Addendum # 2

Date: August 26, 2015

PROJECT #: NT-0014-C03
Garfield James Madison Elementary School
Garfield Public Schools

DESCRIPTION: Addendum # 2

PASSAIC STREET IMPROVEMENT

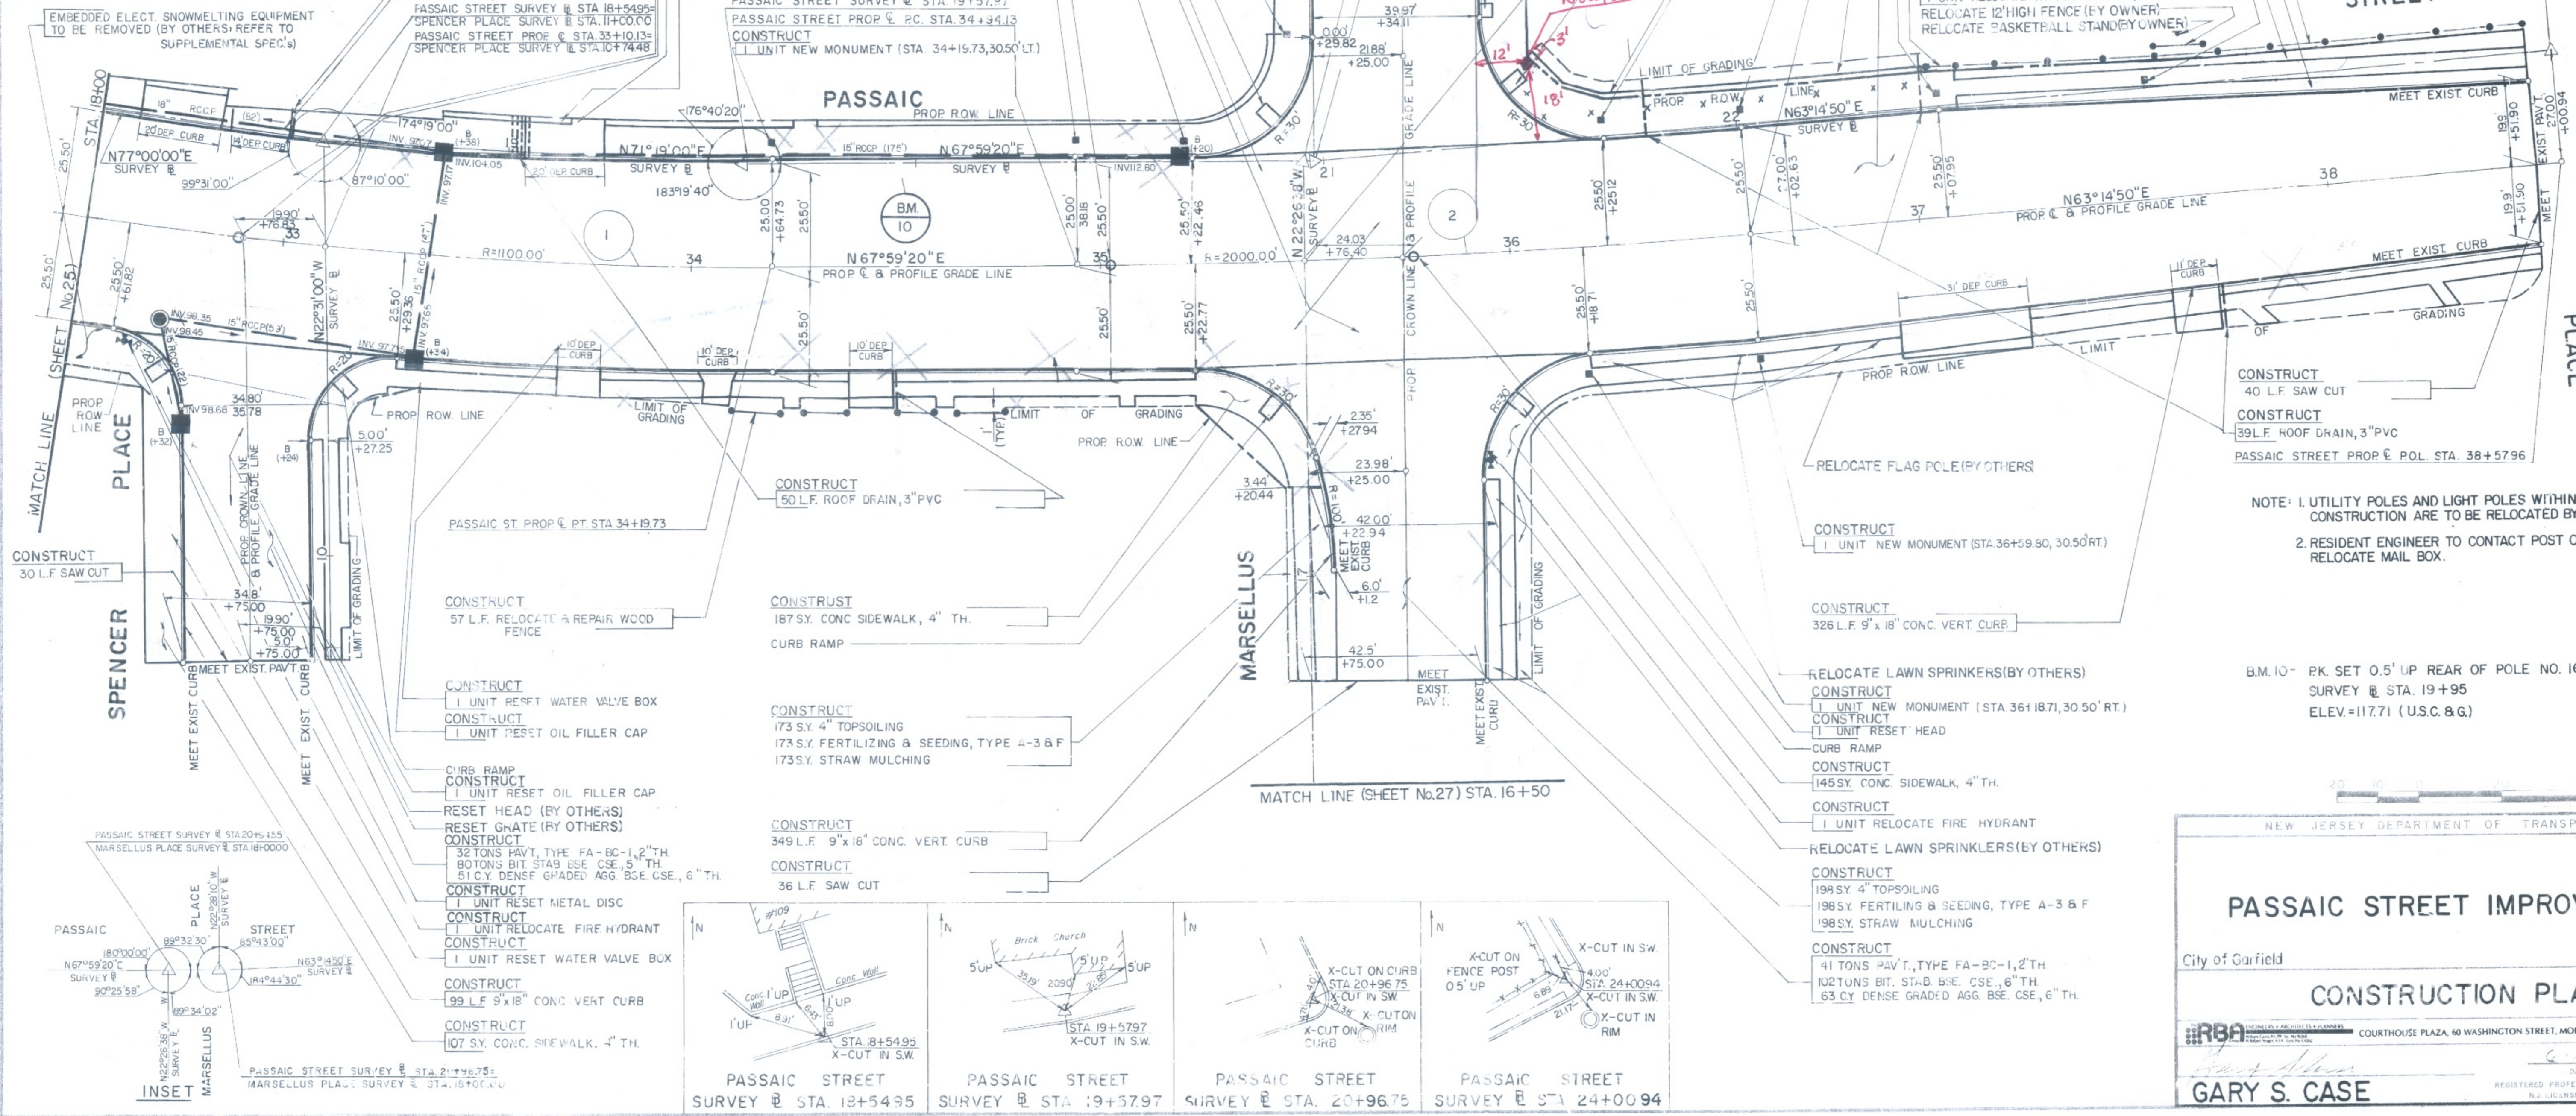
41. Question: Please provide details on the existing masonry retaining wall foundations need to be demolished along Marsellus place and Passaic Street.

- Answer: Refer to Drawing Nos: 26/152, 27/152, 72/152, 73/152 and 137/152, as prepared by RBA for the New Jersey Department of Transportation – Passaic Street Improvement, dated 6/27/85, included with this Addendum as Attachment(s) 2.1, 2.2, 2.3, 2.4, and 2.5. In estimating their bids for removal and disposal of existing masonry retaining wall footings and foundations, Contractors should assume the existence of 25% more underground foundation material than is currently shown on the above drawings
